Access Compliance Report

Public Rights-of-Way

(Curb Ramps)

Intersection ID: 14820	Main Street: BLYTHE_BV	Cross Street: SCOTT_AV	Location: SE
ADA ID: 736545CA2FD2	Ramp Type: PerpDiag	Initial Pass/Fail: Fail	Overall Compliance: No
Codes/Mitigation Info/Possible Solution			Severity Score: 50
			Field Measurements/Component Compliance

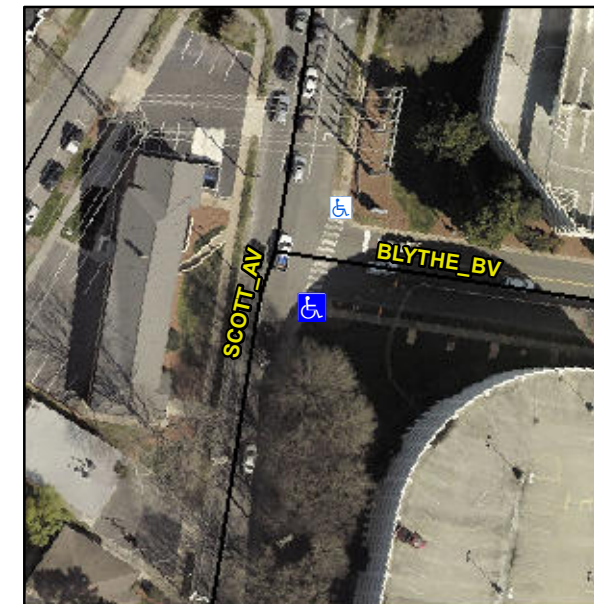
Not Found, R304.2.2, R304.5.3

Compliance	Description	Data	Compliance	Description	Data
N/A	Ramp Length (in)	85.0	No	Ramp Slope (%)	14.1
Yes	Ramp Width (in)	48.0	No	Ramp XSlope (%)	7.6
N/A	Flare Type LT	N/A	N/A	Flare Type RT	N/A
N/A	Flare Slope LT (%)	N/A	N/A	Flare Slope RT (%)	N/A
N/A	Flare Traversable LT?	N/A	N/A	Flare Traversable RT?	N/A
N/A	Landing Length (in)	N/A	N/A	DWS Provided?	N/A
N/A	Landing Width (in)	N/A	N/A	DWS Contrast?	N/A
N/A	Landing Slope (%)	N/A	N/A	DWS Length (in)	N/A
N/A	Landing X Slope (%)	N/A	N/A	DWS Full Width?	N/A
N/A	Landing Curb? (Y/N)	N/A	N/A	DWS Offset (in)	N/A
N/A	Shared Landing?	N/A			
N/A	Gutter Ponding?	N/A	N/A	Gutter Slope (%)	N/A
N/A	Gutter Lip Ht (in)	N/A	N/A	Gutter X Slope (%)	N/A
N/A	Painted X Walk1?	Yes	N/A	Painted X Walk2?	No
	X Walk 1 Direction	To N		X Walk 2 Direction	To W
N/A	X Walk 1 Width (in)	101.0	N/A	X Walk 2 Width (in)	N/A
	X Walk 1 Slope (%)	3.6		X Walk 2 Slope (%)	3.5
	X Walk 1 X Slope (%)	1.8		X Walk 2 X Slope (%)	1.9

Remove & Replace Curb Ramp With Two New Directional Ramps or Equivalent.
